RE: **Dunkin' Donuts**
4208 Central SW
Grading Plan Stamp Date: 7/16/19
Hydrology File: K12D015D

Based on the submittal received on 7/16/19, this project cannot be approved until the following corrections are made:

Grading Plan

C2.1

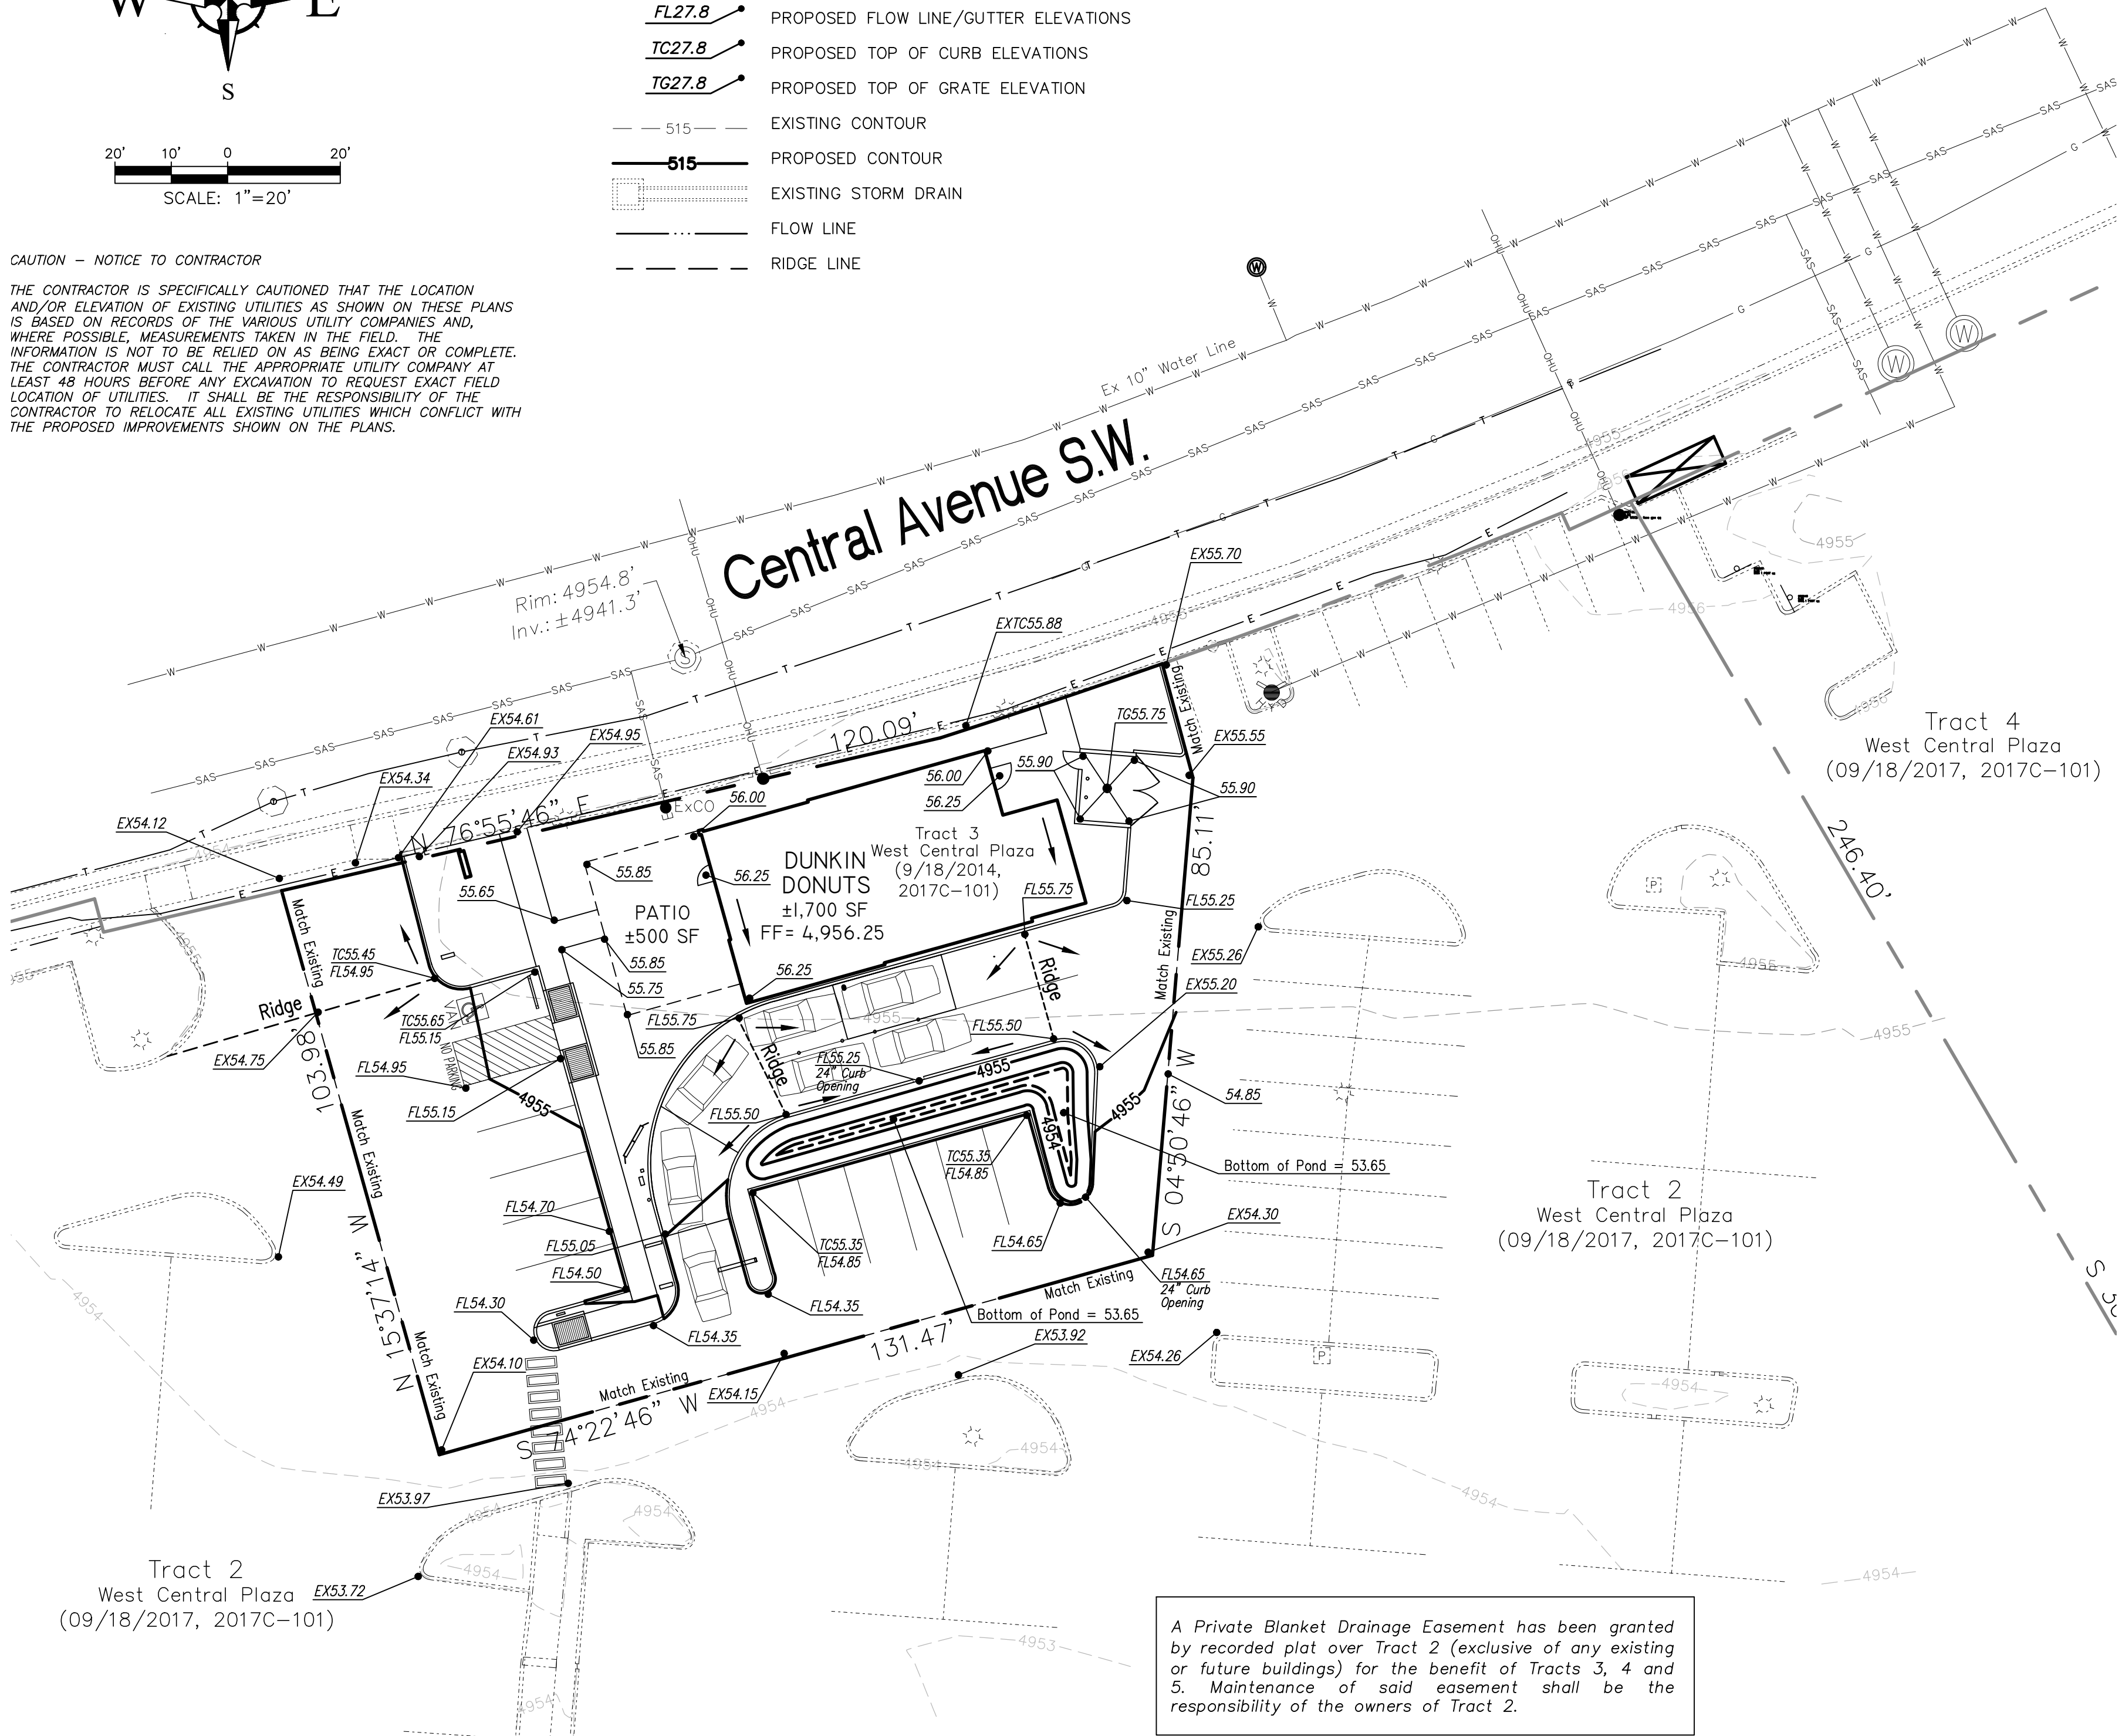
1. The Stormwater Quality (SWQ) bypass volume needs to be calculated. Determine the impervious area draining to your new island pond and deduct from the total SWQ volume requirement for this project.

2. The total SWQV requirement should be determined from the area of redeveloped impervious. If you have existing asphalt to remain, it should be deducted from the requirement.

3. Payment in Lieu (Amount = TBD) of onsite management of the SWQ bypass volume must be made. Unfortunately, the previous plan from 2015 does not adequately treat the SWQV for this site, as it drains to the onsite storm drain and out the Atrisco Drain, bypassing the various ponds in the development.

4. For trash enclosures serving food service developments, demonstrate *control of liquids from dumpster areas* per DPM Chapter 22.9.E, Table 1 by: containing runoff from the dumpster area, preventing outside drainage from entering the dumpster area, and discharging to the sanitary sewer. If this information is on the utility plan please provide it, or show on the grading plan.
